PROPOSED USE SCHOOL BUILDINGS /MODULAR

PROJECT NAME:	TEMP TRAILER FOR CLASS ROOM GULLIVER PREP 6575 SW 88 ST M2026011895
PROJECT/AGREEMENT NUMBER:	2026
PROJECT DESCRIPTION:	8050 SQFT OF 10 TEMP PORTABAL TRAILERS PER PLANS REPLACING VACANTLAND
IS THIS AN AFFORDABLE HOUSING PROJECT?	No

TEMPORARY CLASSROOMS
6575 North Kendall Drive, Pinecrest, FL 33156

Narrative Response to Comments for M Process # M2026011895

Figure 1: Gulliver Prep Modular Classroom

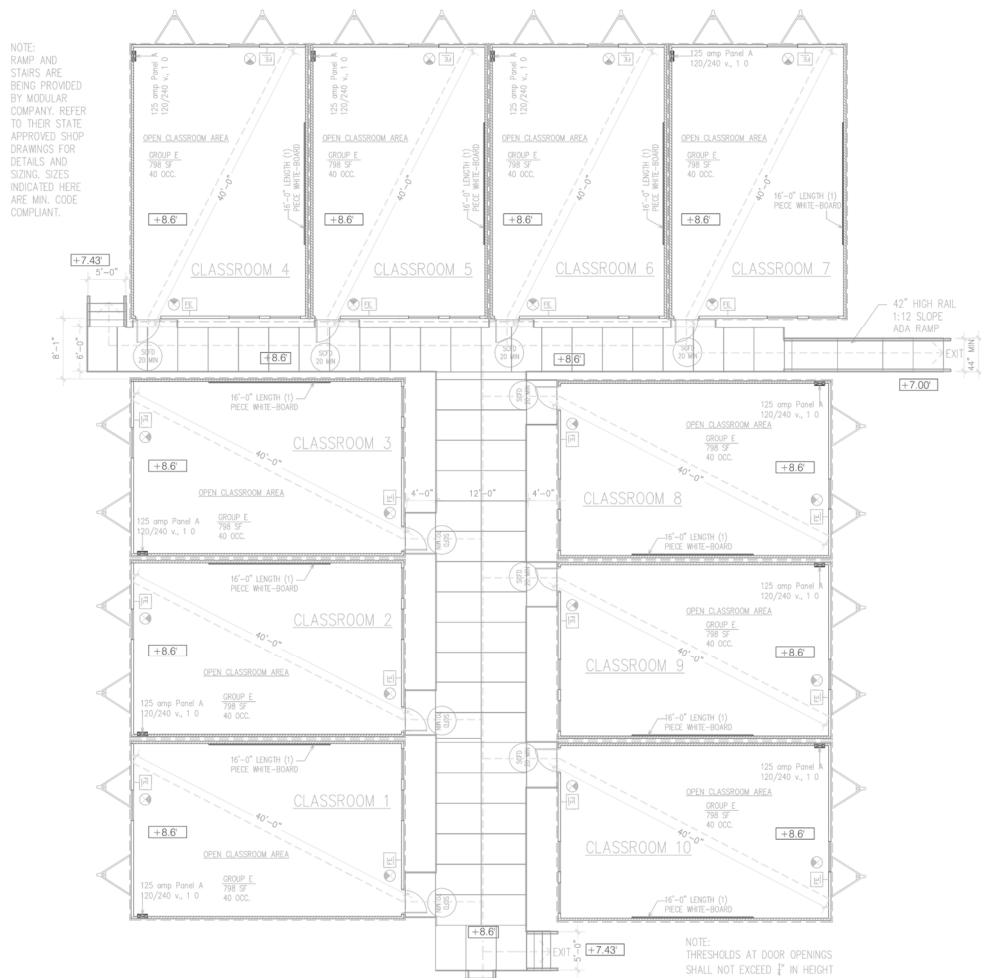
Comment: THE ANALYSIS TO EXEMPT THE FIRE SPRINKLER INSTALLATION REQUIREMENT OF NFPA

101: 14.3.5.1 BASED OF EXEMPTIONS REFERENCED IN SECTIONS 14.3.5.2 (1) AND 14.3.5.2 (2) REQUIRES DISCUSSION THROUGH A MEETING INCLUDING OWNER REPRESENTATIVE, DESIGN PROFESSIONAL, FIRE PLANS PROCESSOR, AND CAPT. RAUL RODRIGUEZ.

Based on the proposed use of the modular classrooms, the classrooms meet the classification for permanent buildings in accordance with the FFPC. Accordingly, EB respectfully requests that the buildings be classified as "non-relocatable" under FFPC Section 14.3.5.2.
